General Electric Company
175 Curtner Avenue, San Jose, CA 95125

Subject: Submittal Supporting Accelerated ABWR Schedule - ISLOCA (Issue #42)

Enclosed is a SSAR markup resolving ISLOCA Issue #42. This replaces the text part of my April 30, 1993 letter. However, the marked up P&IDs of my April letter still apply and they are not repeated in this transmittal.

RESOLUTION OF INTERSYSTEM LOSS OF COOLANT ACCIDENT
FOR ABWR

Figure 10.4-6 CONDENSATE SYSTEM (Sheet 2 of 2)

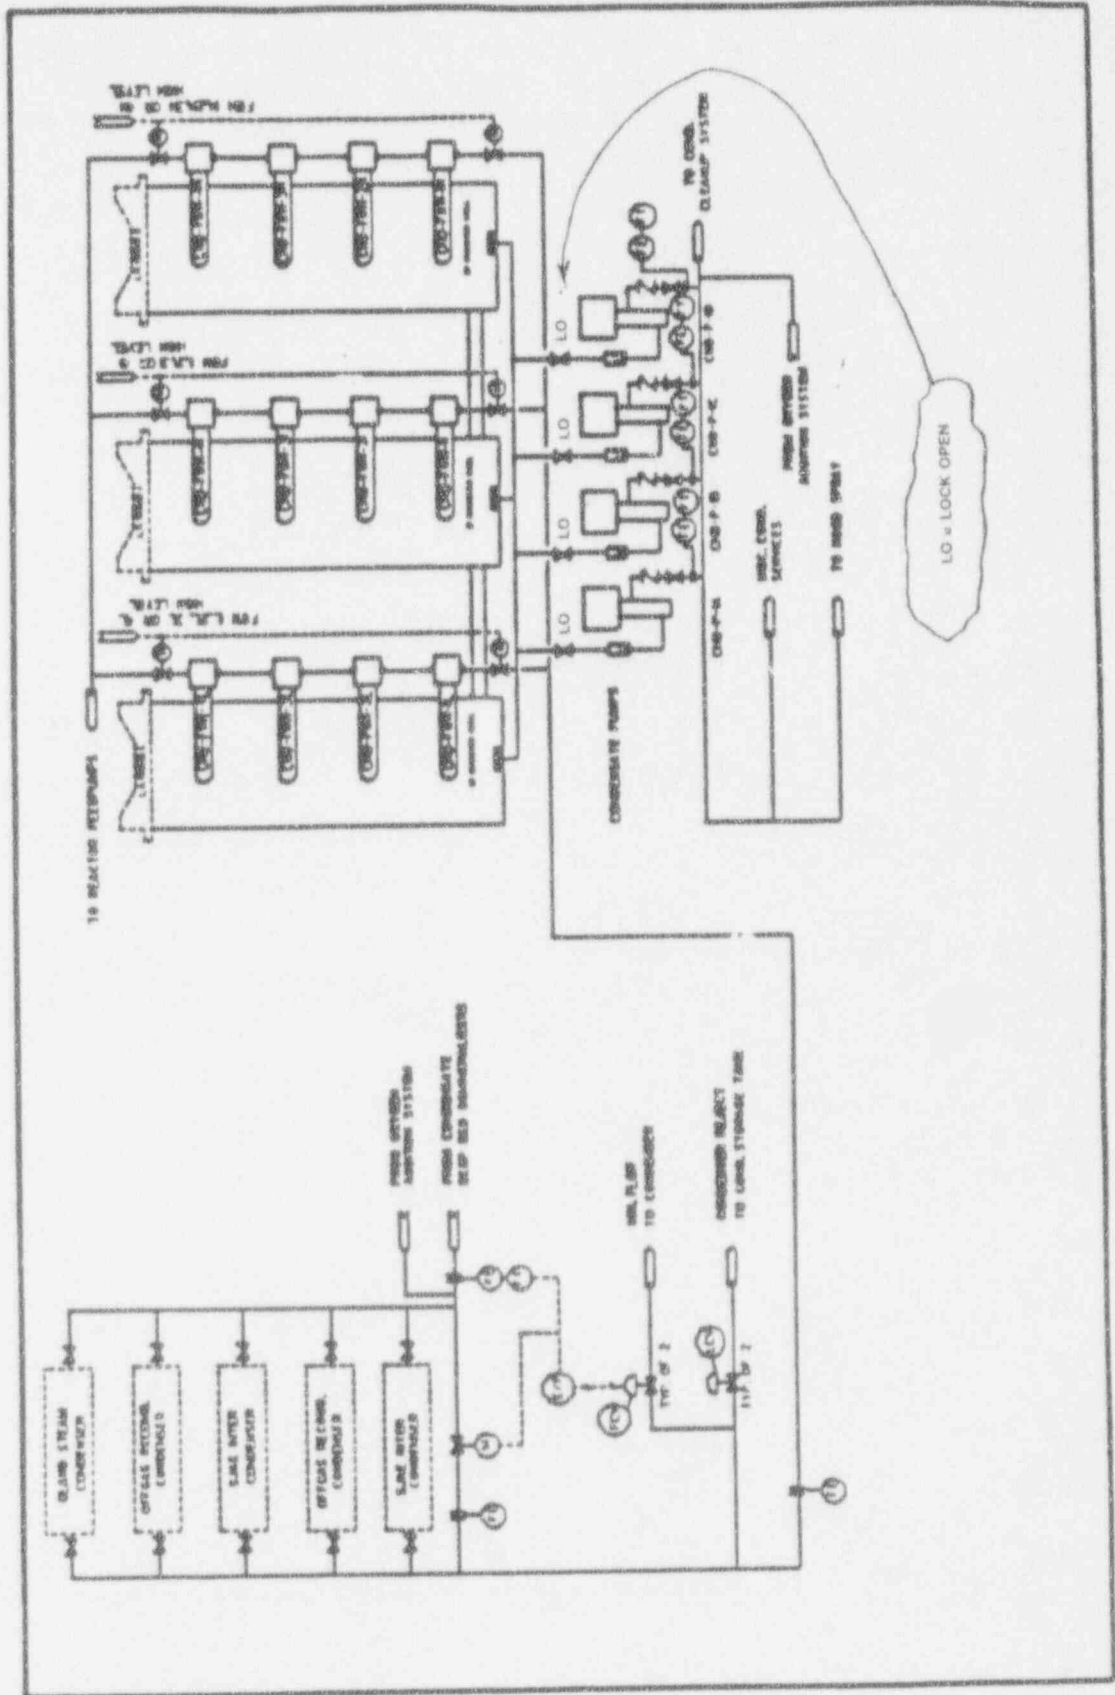
430.90
